SERVICE BULLETIN 34T-06-338-01

Models Affected: 34 Trawler – Hulls GM101 through GM 185

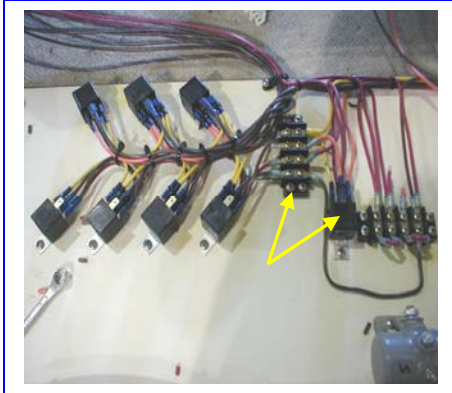
It has come to our attention that the high water bilge pump system in the 34Trawler is not hooked to the remainder of the bilge pump system. The purpose of this bulletin is to provide direction to rewire the system so that the when the high water bilge pump turns on all the bilge pumps in the boat turn on at the same time.

The current configuration does not pose a problem with any of the individual bilge pumps operation. Reconfiguring the system will insure that all pumps will pump at the same time when the high water pump is activated.

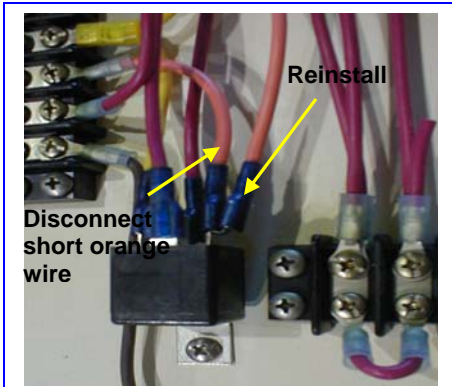
Step 2: Remove the vent box from the engine room area just below and forward of the engine room access steps. Locate the power board behind the MDP. The high water relay and terminal is located high up on the power board, separate from other relay systems.

Step 3: Between the high water relay and the terminal strip, there is an orange 14ga jumper wire (about 3" long) that needs to be disconnected at the relay end. It is piggybacked with another orange wire. Remove the wire connected to relay and replace with long orange wire that is piggybacked.

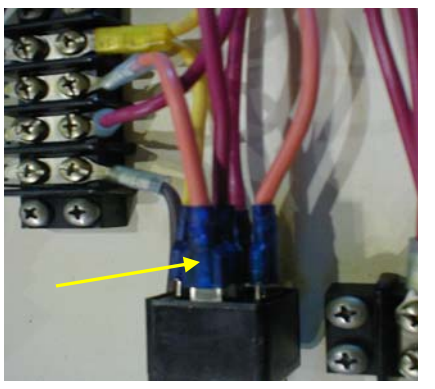
Step 4: Take the red wire that is at the top of the relay and remove from relay. Place the short orange wire in this spot.

Step 5: Piggyback the red wire that was removed from this spot on with the orange wire.
